# Access Compliance Report

## Public Rights-of-Way

### (Curb Ramps)

Intersection ID: 31418	Main Street: CHEVIOTT_HILL_LN	Cross Street: GUILDHALL_LN	Location: NW
ADA ID: 18418C8E0DCC	Ramp Type: PerpDiag	Initial Pass/Fail: Fail	Overall Compliance: No
Severity Score: 8.75			
Codes/Mitigation Info/Possible Solution		Field Measurements/Component Compliance

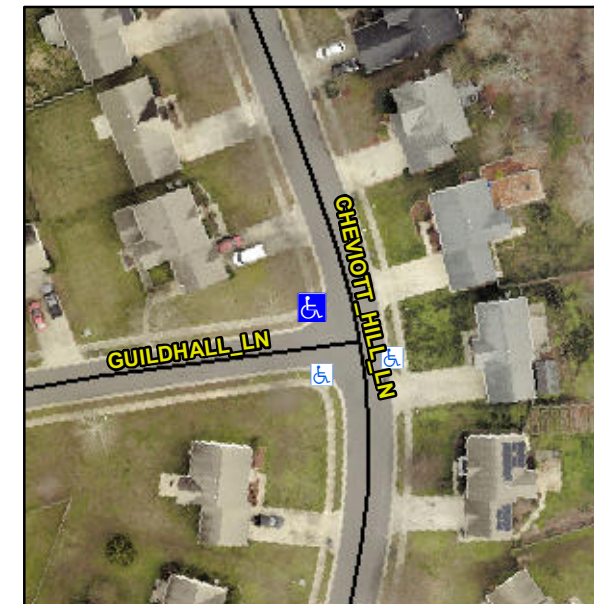
**Not Found, R304.5.1**

Compliance	Description	Data	Compliance	Description	Data
N/A	Ramp Length (in)	50.0	Yes	Ramp Slope (%)	7.4
No	Ramp Width (in)	39.0	Yes	Ramp XSlope (%)	1.5
N/A	Flare Type LT	N/A	N/A	Flare Type RT	N/A
N/A	Flare Slope LT (%)	N/A	N/A	Flare Slope RT (%)	N/A
N/A	Flare Traversable LT?	N/A	N/A	Flare Traversable RT?	N/A
N/A	Landing Length (in)	N/A	N/A	DWS Provided?	N/A
N/A	Landing Width (in)	N/A	N/A	DWS Contrast?	N/A
N/A	Landing Slope (%)	N/A	N/A	DWS Length (in)	N/A
N/A	Landing X Slope (%)	N/A	N/A	DWS Full Width?	N/A
N/A	Landing Curb? (Y/N)	N/A	N/A	DWS Offset (in)	N/A
N/A	Shared Landing?	N/A			
N/A	Gutter Ponding?	N/A	N/A	Gutter Slope (%)	N/A
N/A	Gutter Lip Ht (in)	N/A	N/A	Gutter X Slope (%)	N/A
N/A	Painted X Walk1?	No	N/A	Painted X Walk2?	No
	X Walk 1 Direction	To S		X Walk 2 Direction	To E
N/A	X Walk 1 Width (in)	N/A	N/A	X Walk 2 Width (in)	N/A
	X Walk 1 Slope (%)	5.9		X Walk 2 Slope (%)	5.8
	X Walk 1 X Slope (%)	2.8		X Walk 2 X Slope (%)	8.4

**Remove & Replace Curb Ramp With Two New Directional Ramps or Equivalent.**
